AURIX™ TC33x/TC32x errata sheet

Marking/Step: (E)ES-AA, AA

About this document

Figure 1 Message buffer transfer from Message RAM to OBF

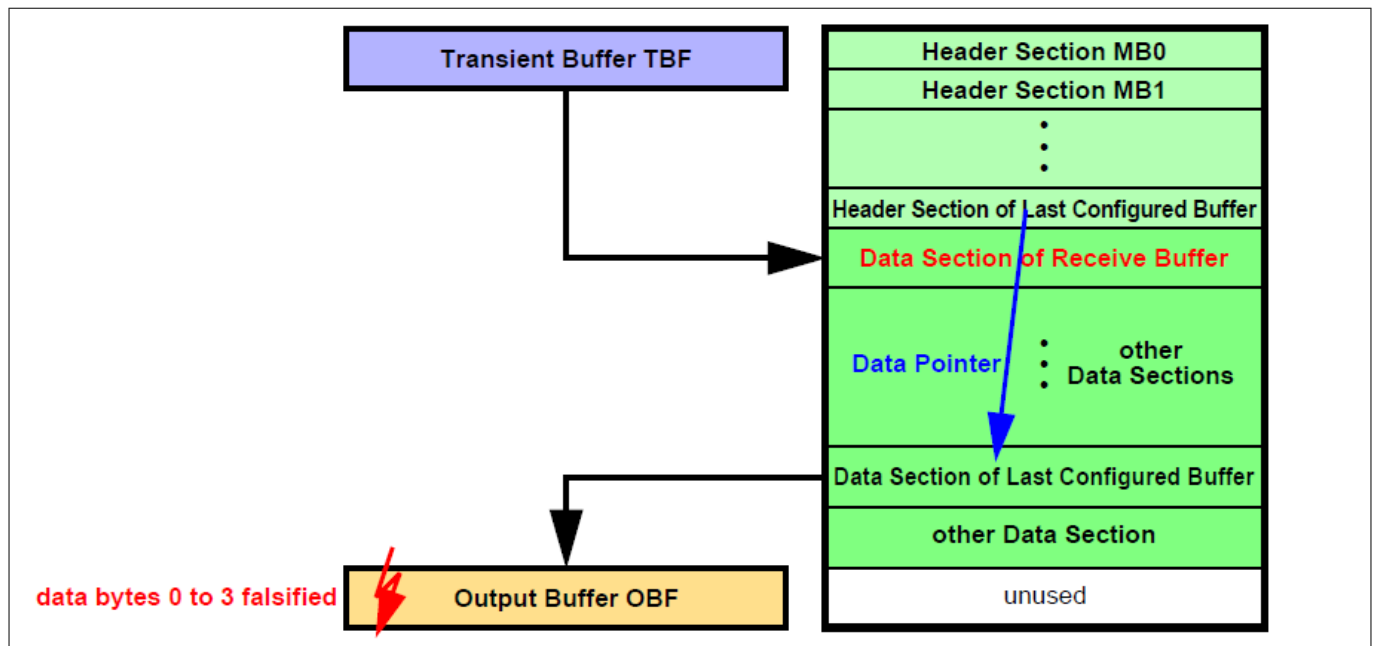
a) When a message is transferred from the Last Configured Buffer in the Message RAM to the OBF and PLC = 127 it may happen, that at the end of the transfer the OBF word on address 00h (payload data bytes 0 to 3) is overwritten with unexpected data (see [Figure 1](#))

Figure 2 Message buffer transfer from IBF to Message RAM

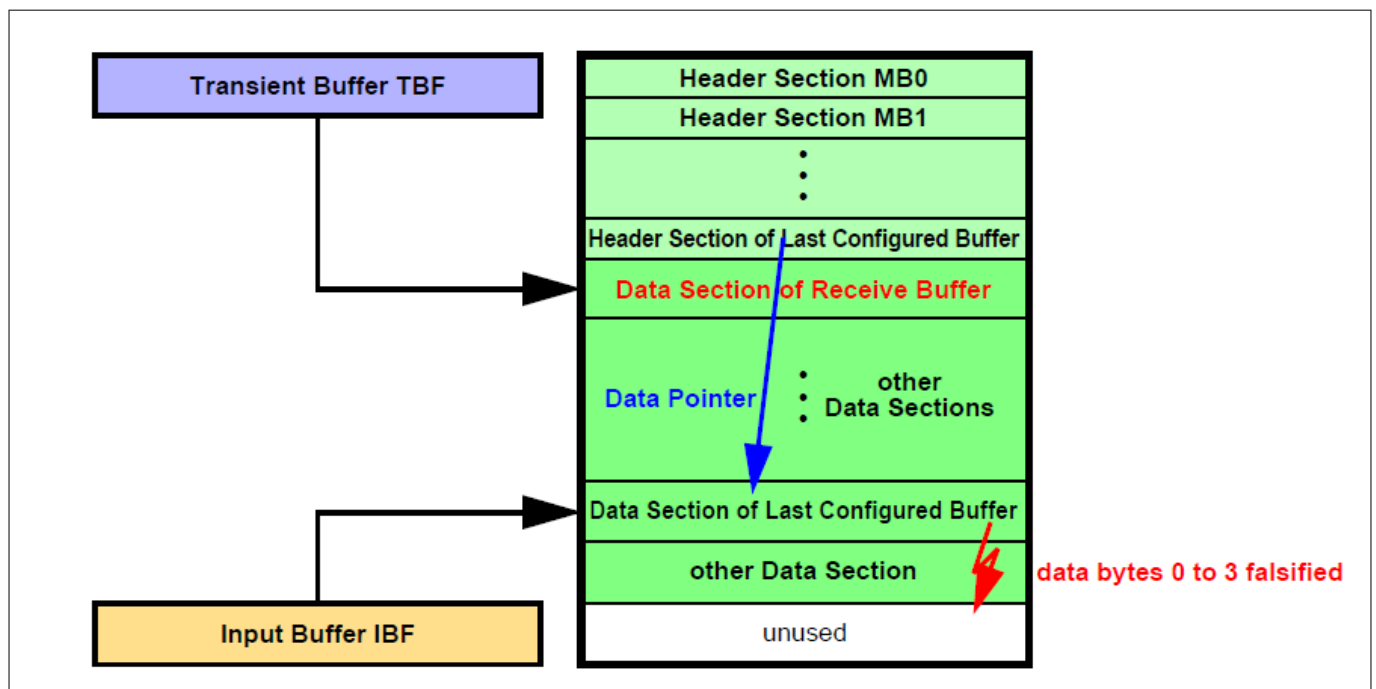
b) When a message is transferred from IBF to the Last Configured Buffer in the Message RAM, it may happen, that at the end of the transfer of the Data Section one additional write access overwrites the following word, which may be the first word of another message's Data Section in the Message RAM (see [Figure 2](#))

Figure 3 Message RAM configurations

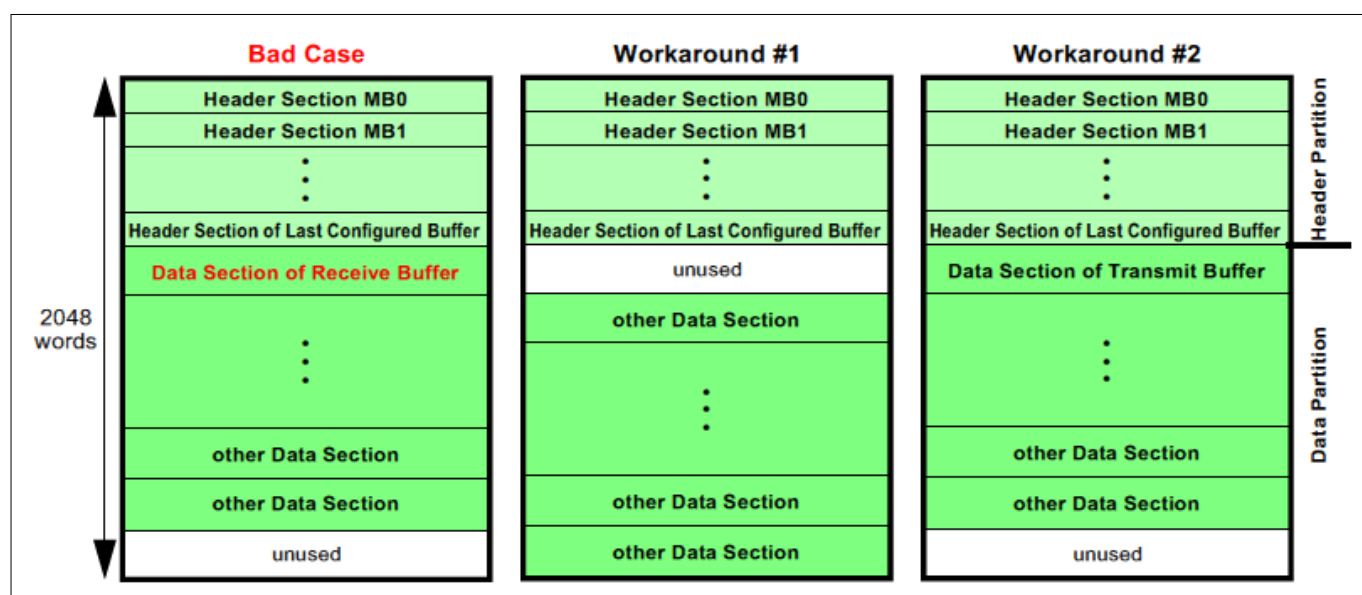
The erratum is limited to the case when (see [Figure 3](#) “Bad Case”):

Ensure that the Data Section directly following the Header Partition is assigned to a transmit buffer.

Figure 8 Package Outlines TQFP-144 for TC33x/TC32x

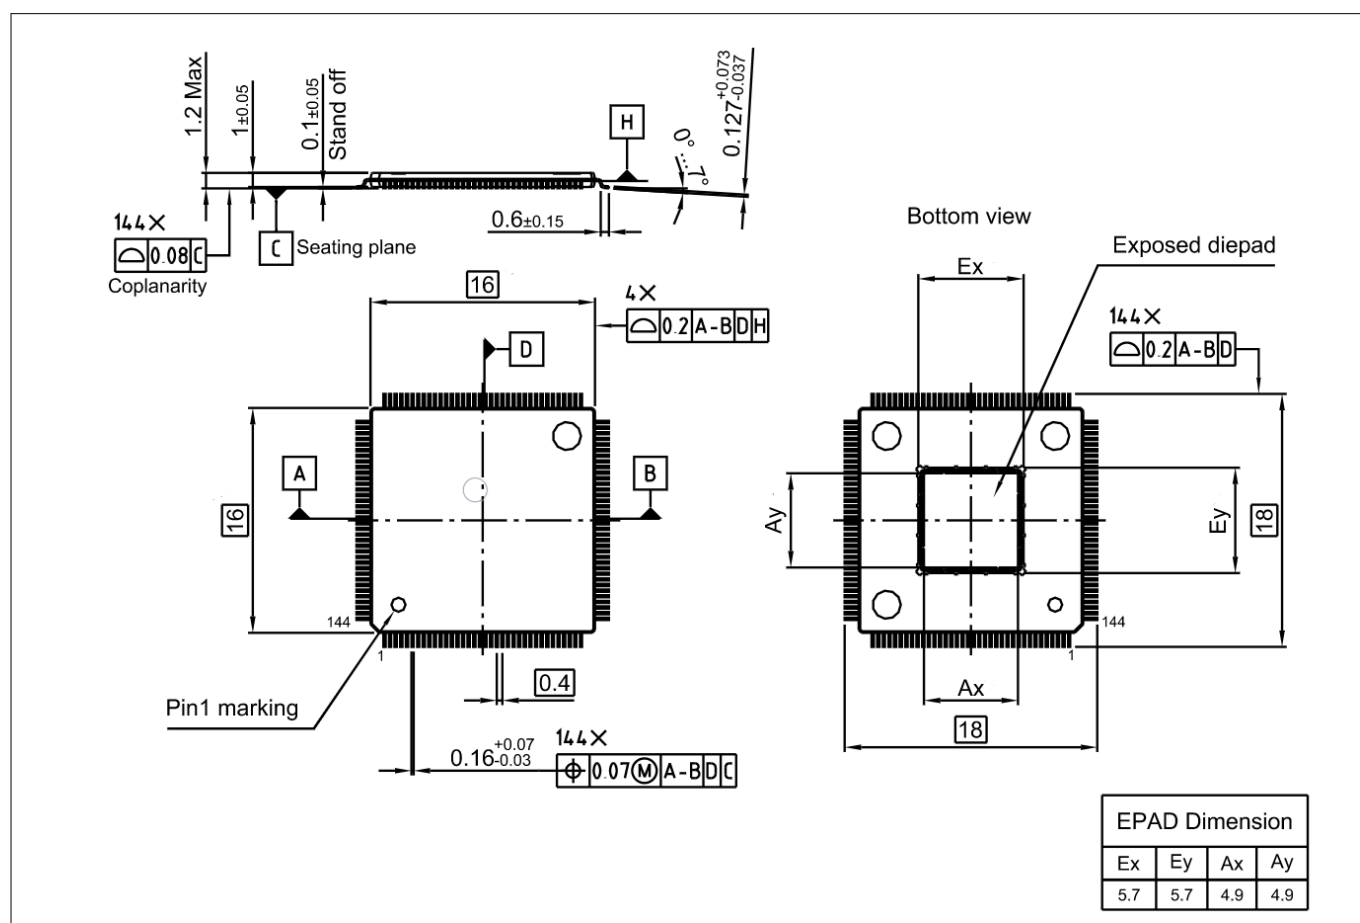
Furthermore, for the exposed die pads, the maximum boundary of the structural corner protrusions to be considered during system design and integration has been added.

Note: For the exposed diepad of the TQFP-144 package of the TC33x/TC32x, structural corner protrusions have to be considered for purposes of system design and integration with a maximum boundary of 6.2 mm.

This information shall substitute the corresponding information in the TC33x/TC32x AA-step Data Sheet V1.1.

Figure 9 Package Outlines TQFP-100 for TC33x/TC32x

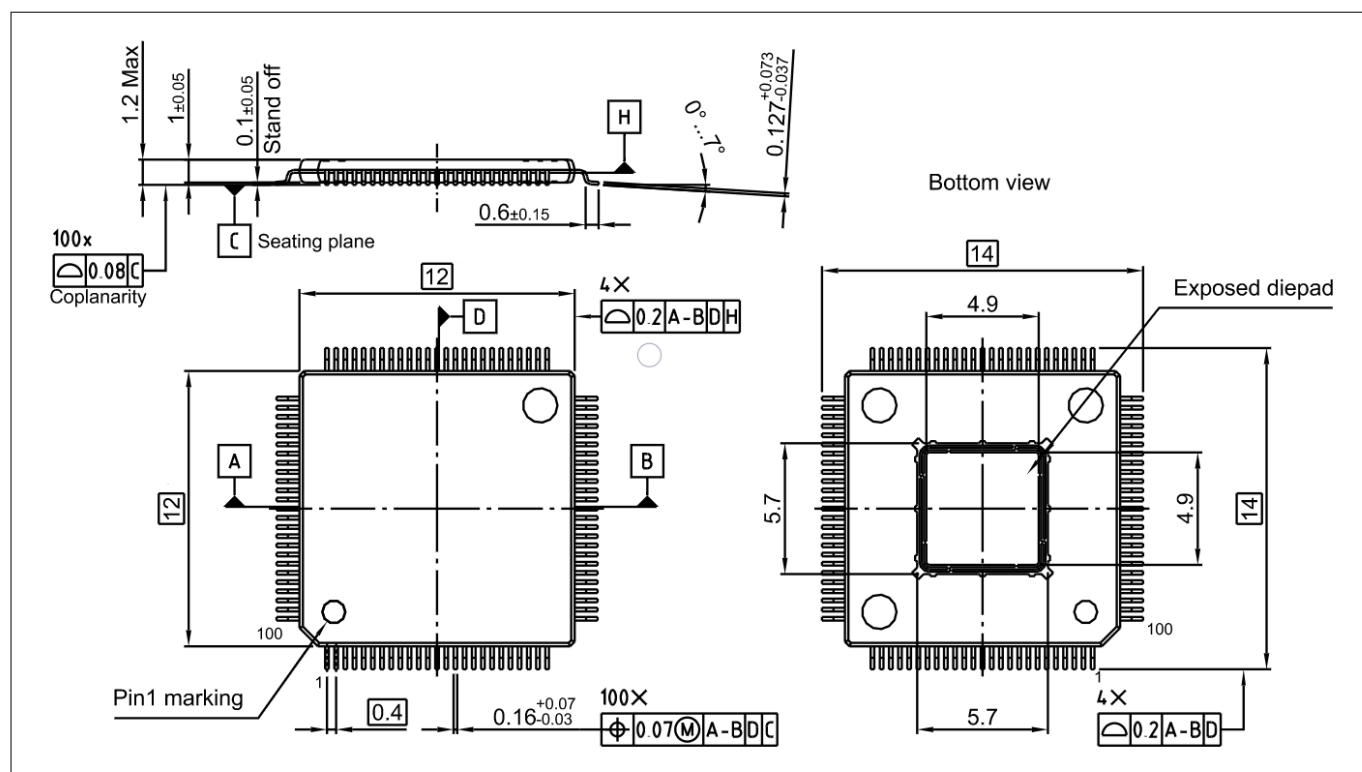
Note: For the exposed diepad of the TQFP-100 package of the TC33x/TC32x, structural corner protrusions have to be considered for purposes of system design and integration with a maximum boundary of 6.3 mm.

Figure 11 VCAP behavior during start-up when EVRC regulator is used - corrected

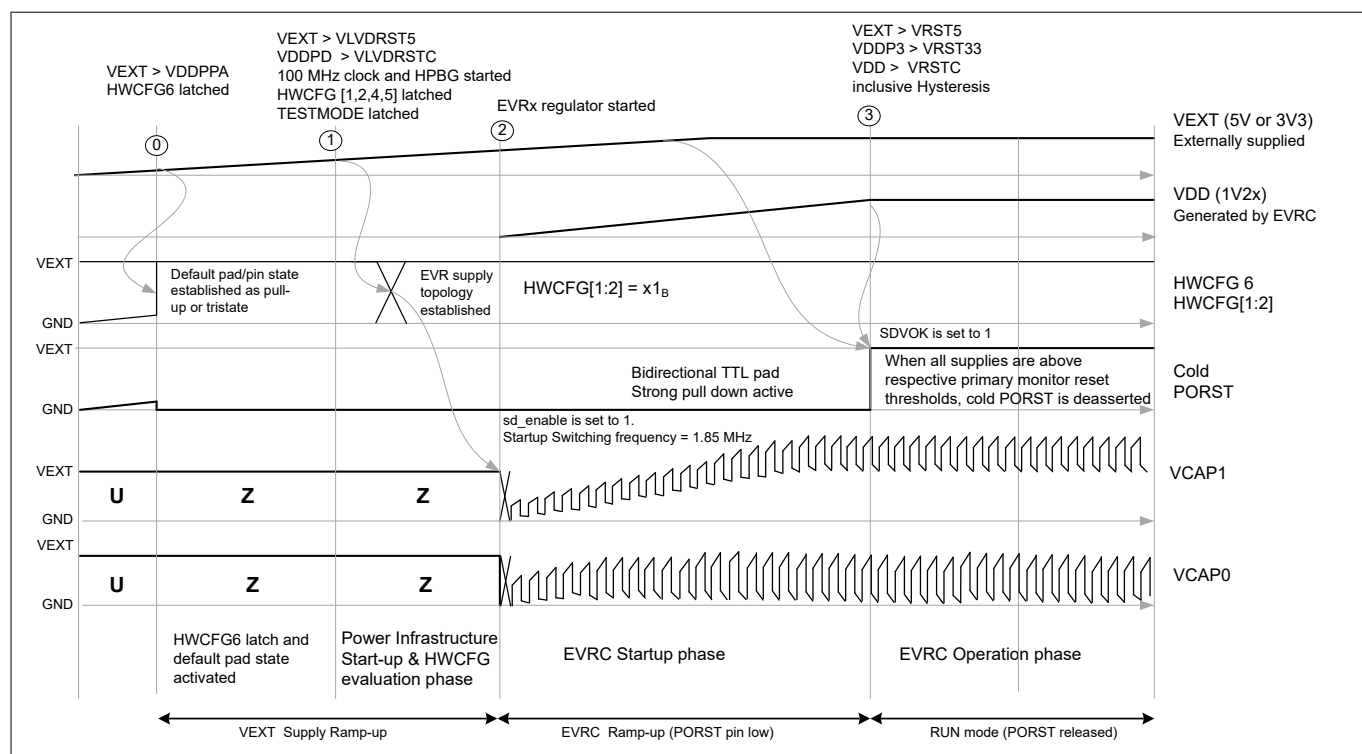
See corrected figures included below.
